MP101

MP 104

MP304

B3 water level
warrick dwg.pdf

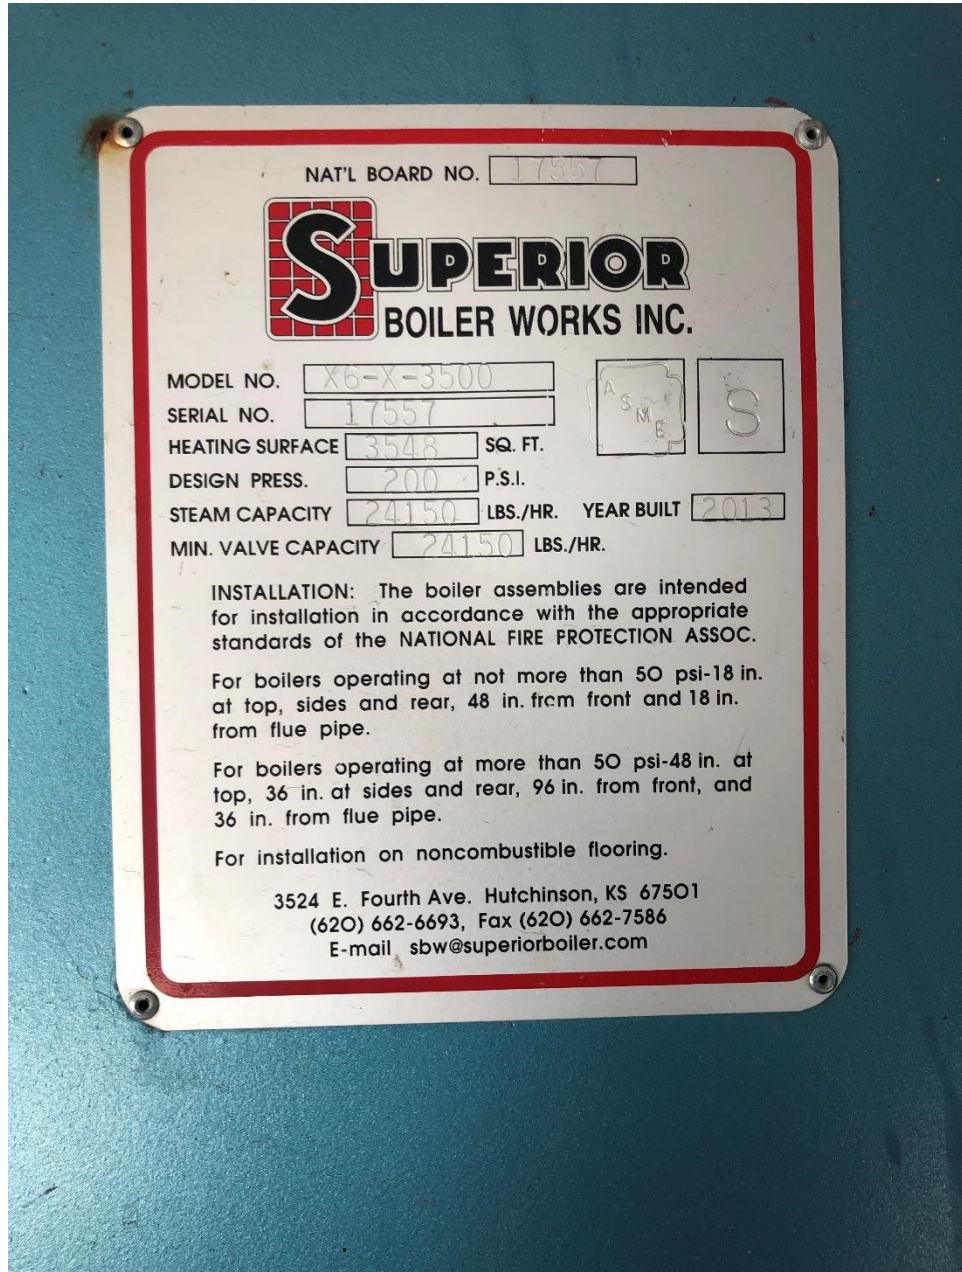
Below is a quick list per item of the kind of information we would like to confidently get the conversions configured.

- Safety Relief Valve setting
125, 130, 135 PSIG
- Existing level controller

- Existing feedwater valve (open/close vs modulating) **MODULATING**

- Pressure Vessel MAWP if not on the nameplate
- Any dimensional or factory provided documentation
 - o Specifically furnace dimensions for burner conversion configuration. Mounting ring dimensions, furnace pressure, shape and depth. This may be information we can find based on model knowledge.

Documents provided are for reference only shop drawings from previous construction project.

Existing Surge Tank

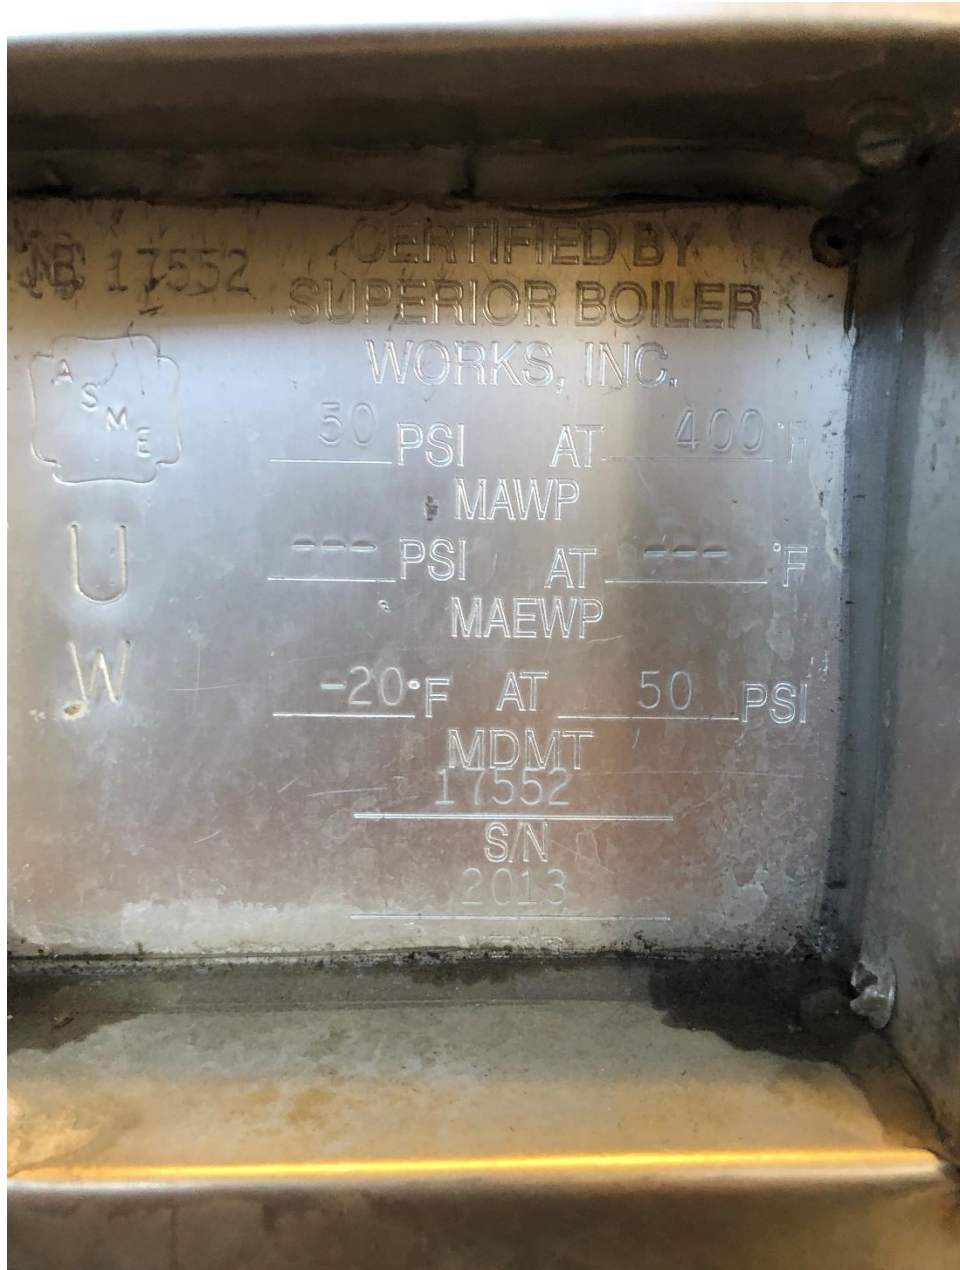
- Tank Nameplate

- Vessel Gallonage – or Vessel Diameter and Length
- Any dimensional or factory provided documentation (dimensional, P&IDs, Wiring diagrams)
- Pressure Vessel MAWP if not on the nameplate – or stated if atmospheric

- Pump nameplates and motor hp if available

- Tank stand height

- Unit photos showing level controls if dimensional information is not available.

Existing Deaerator Tank

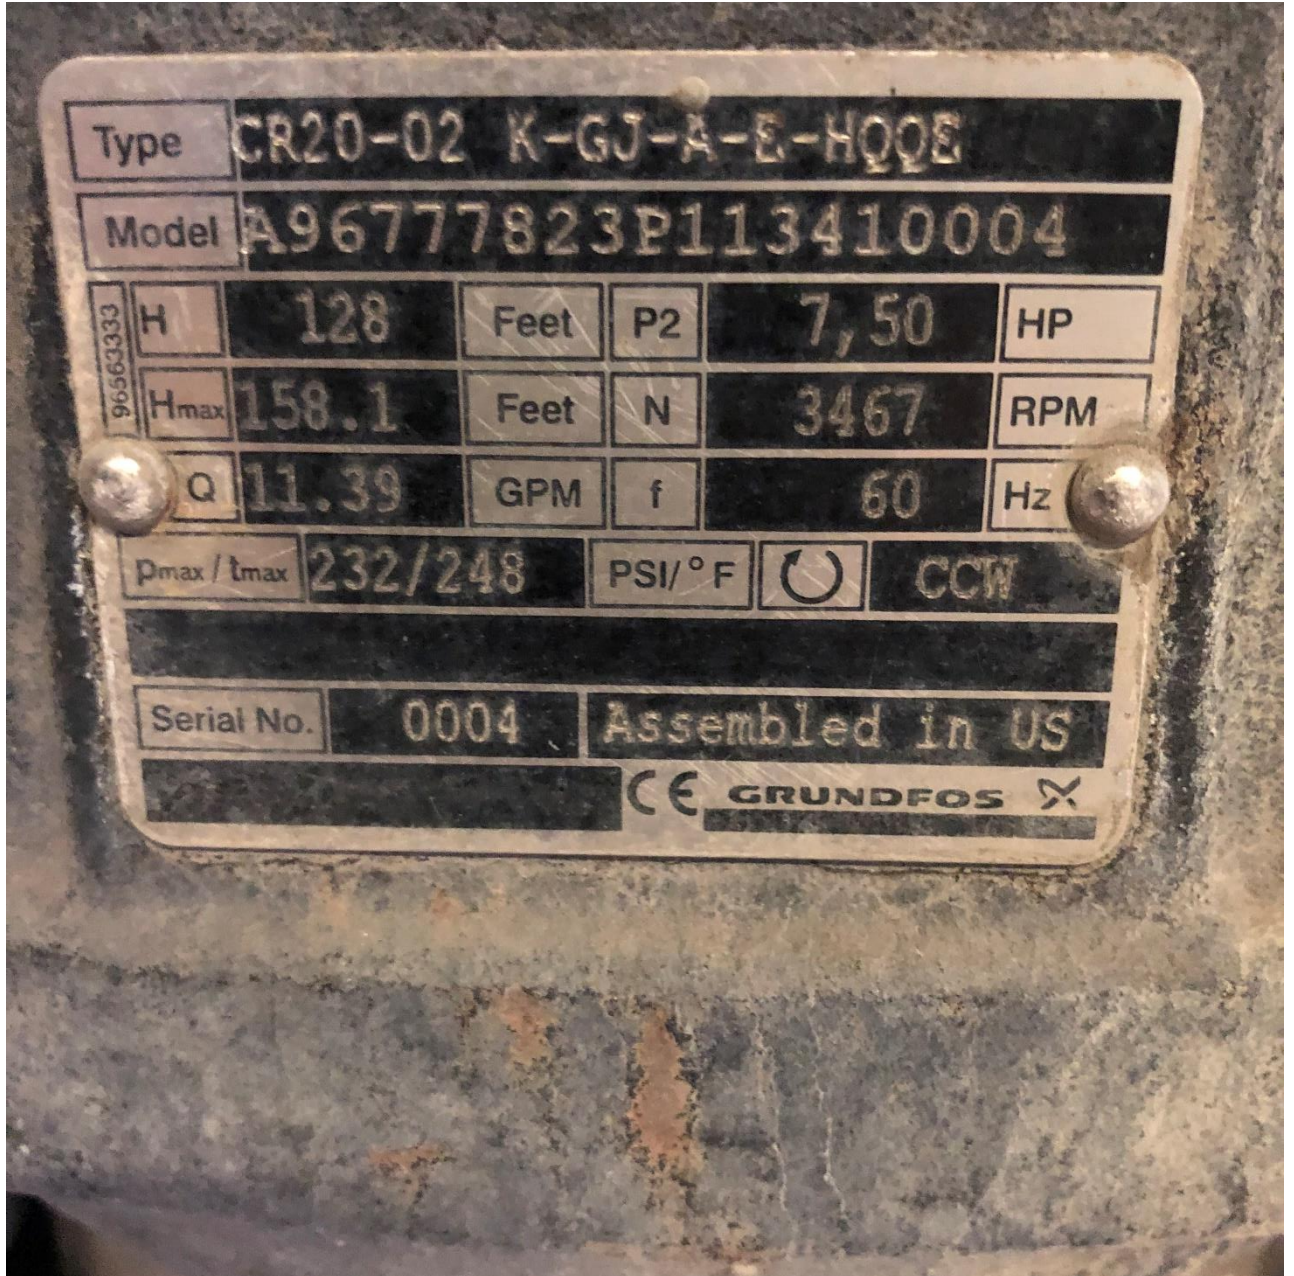
- Tank Nameplate

- Vessel Gallonage – or Vessel Diameter and Length
- Any dimensional or factory provided documentation (dimensional, P&IDs, Wiring diagrams)
- Pressure Vessel MAWP if not on the nameplate

- Pump nameplates and motor hp if available

-
- Tank stand height
- Unit photos showing level controls if dimensional information is not available.
